AGENDA
Veneta Planning Commission
TUESDAY – October 6, 2015 – 6:30 p.m.
Veneta City Hall

**VENETA PLANNING COMMISSION'S
STAFF REPORT**

Veneta Veterinary Hospital – Site Plan Review

**Veneta Veterinary Hospital, Site Plan Review (SR-3-15),
Assessor's Map and Tax Lot No. 17-05-31-20-01300**

1 LANDSCAPE PLAN
L1.1

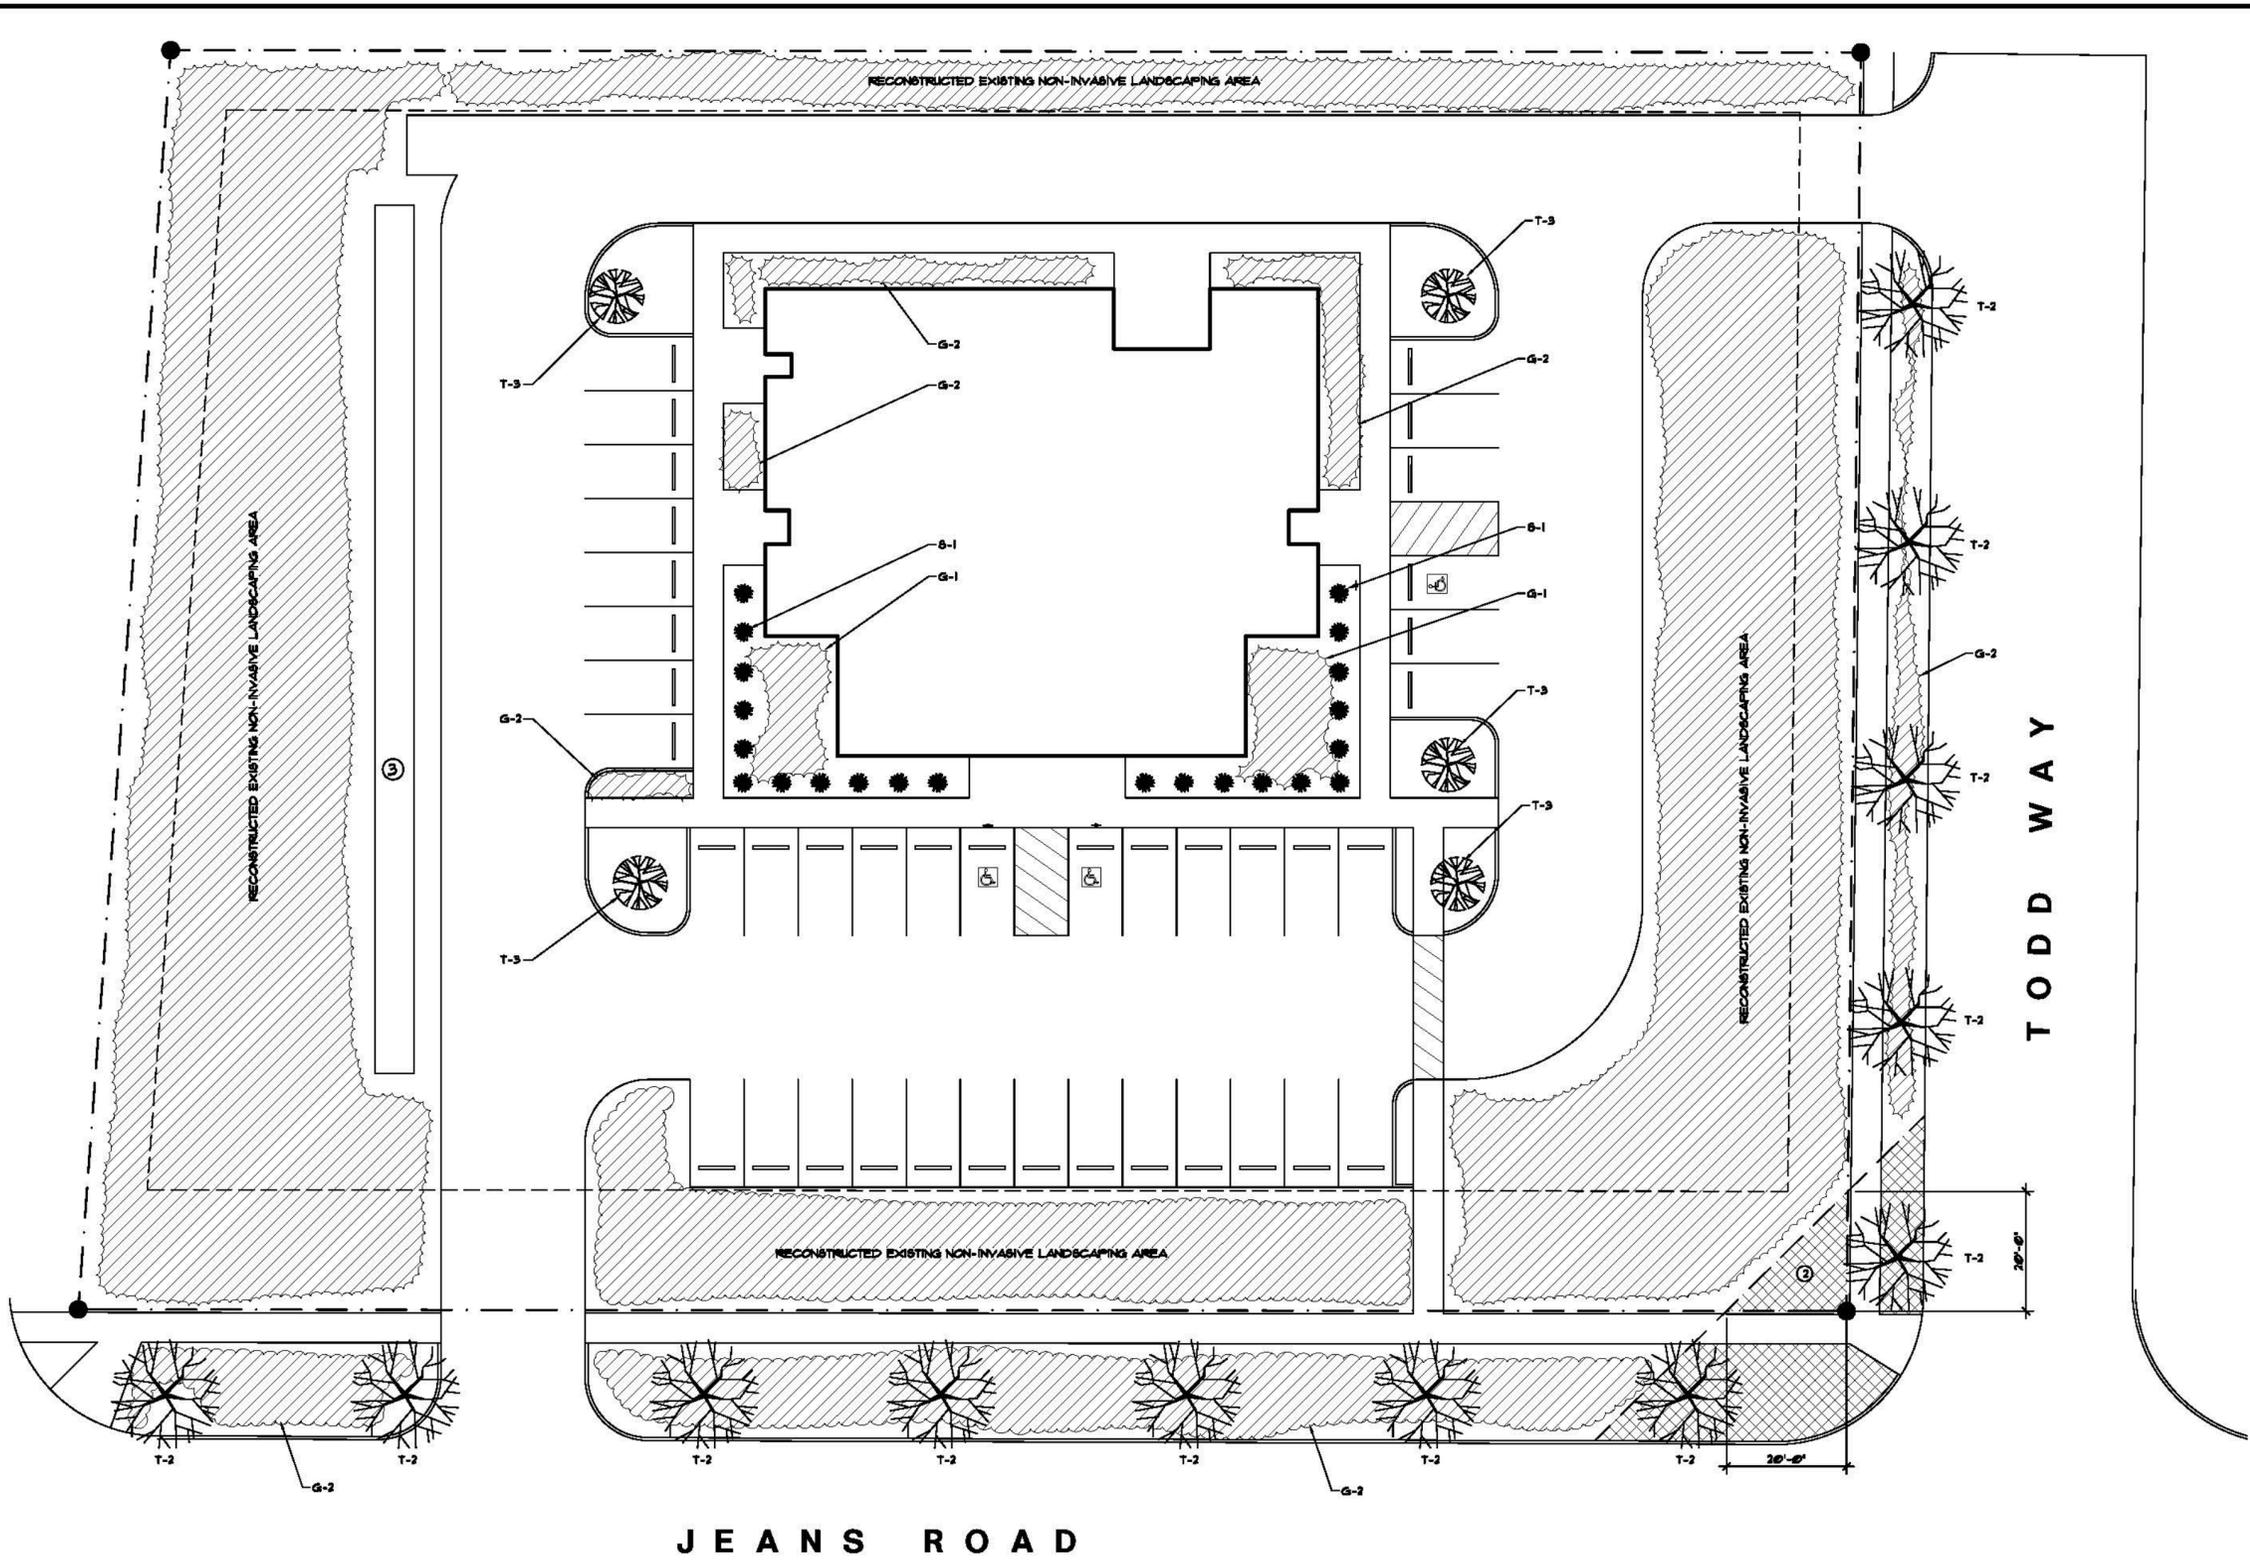
As conditioned, the proposal is consistent with this standard. The applicant has submitted a Proposed Landscape Plan (Sheet L1.1) which depicts “reconstructed existing non-invasive landscaping” within the required 5-foot yard from off-street parking areas. It is unclear from the submitted Landscape Plan what type of landscaping is proposed within the required 5-foot yard for off-street parking.

As conditioned, the proposal is consistent with this standard. Ten (10) percent of the site equals to an approximate +/-5,749 square feet. It appears from the submitted Landscape Plan (Sheet L1.1), the applicant is proposing more than 20,000 square feet (or 35%) of landscaping including; stormwater swale plantings and parking lot landscape areas. However, the Landscape Plan indicates large areas of “reconstructed existing non-invasive landscape area” and it unclear what plant material is proposed in those areas given there is generally no existing landscaping at the subject site. Prior to construction, the applicant shall submit and receive approval of a Final Landscape Plan depicting a minimum of 5,749 square feet of landscaped area in accordance with Veneta Land Development Ordinance No. 493, Section 5.12(3)(b) – Minimum Landscaped Area.

- 12) The applicant shall submit and receive approval of a revised Landscape Plan per Veneta Land Development Ordinance No. 493, Section 6.06(5), consistent with all conditions of approval including:

- (b) The type of plant materials proposed within the required 5-foot yard for off-street parking areas in accordance with Veneta Land Development Ordinance No. 493, Section 4.06(5)(d) and Section 5.12 – Landscaping.

- (c) Ground cover plants sized and spaced to achieve 75% coverage of the area not covered by shrubs or tree canopy in accordance with Veneta Land Development Ordinance No. 493, Section 5.12(5) – Minimum Percentage Ground Cover.

- (d) The type of plant materials proposed within the stormwater detention and treatment area (rain garden) in accordance with the City of Veneta’s stormwater detention standard (PSWMM Revision #4, August 1, 2008) per Veneta Land Development Ordinance No. 493, Section 5.16 – Stormwater Detention and Treatment and the City Engineer.
